Executive Director's Recommendation

Commission Meeting: December 1, 2016

PROJECT President Franklin D. Roosevelt Prayer Plaque World War II Memorial The National Mall Washington, DC	NCPC FILE NUMBER 7727
SUBMITTED BY United States Department of Interior National Park Service	NCPC MAP FILE NUMBER 00.00(73.10)44248
REVIEW AUTHORITY Per 40 U.S.C § 8905 and Public Law 113-123	APPLICANT'S REQUEST Approval of comments on concept design
	PROPOSED ACTION Approve comments as requested
	ACTION ITEM TYPE Staff Presentation

Alternative II: Four Panel plaque

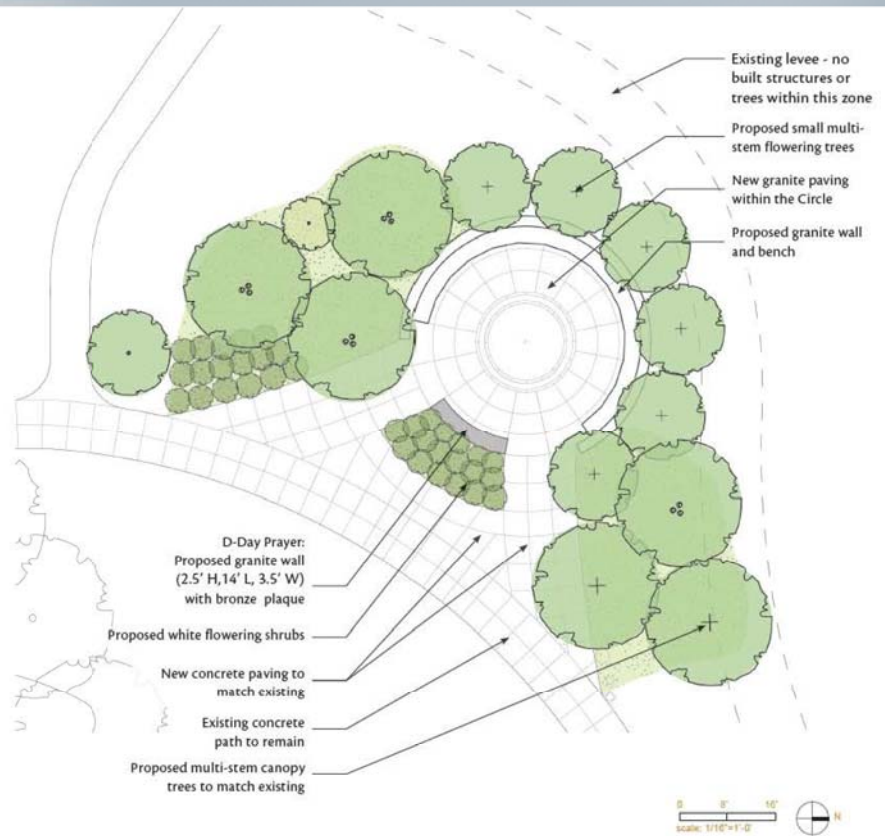
Supports Alternative II, at the edge of the Circle of Remembrance, as the preferred location and design of the President Franklin D. Roosevelt prayer plaque.

Notes that Alternative II completes the geometric form of the circle while incorporating the plaque as a free-standing element, separated from the circular wall enclosure by two pedestrian pathways.

Staff notes that a program for the plaque has not been defined and that the applicant should consider what types of ceremonies, services, or events might be planned and how much visitation the plaque or inscription will receive once it is in place. However, staff recommends that Alternative II is the best location and design for the FDR prayer because it formally and materially integrates the prayer plaque with the Circle of Remembrance, it complies with the original WWII design intent, and it allows the D-Day prayer to be read comfortably from a standing position.

Recommends that the sponsor continue to refine the design of the prayer plaque, ensuring that the plaque is:

- complementary in scale and material with the proposed retaining wall and benches encompassing the Circle of Remembrance.
- formed with a height and size that promotes legibility while discouraging unintended uses such as sitting or sleeping.
- made of a material and color that harmonizes with the surrounding landscape context.
- planted with adjacent vegetation that promote long-term legibility and ease of maintenance.
- located to protect existing views to the National Mall, including views to the World War II Memorial primary precinct, the Washington Monument, and Constitution Gardens.
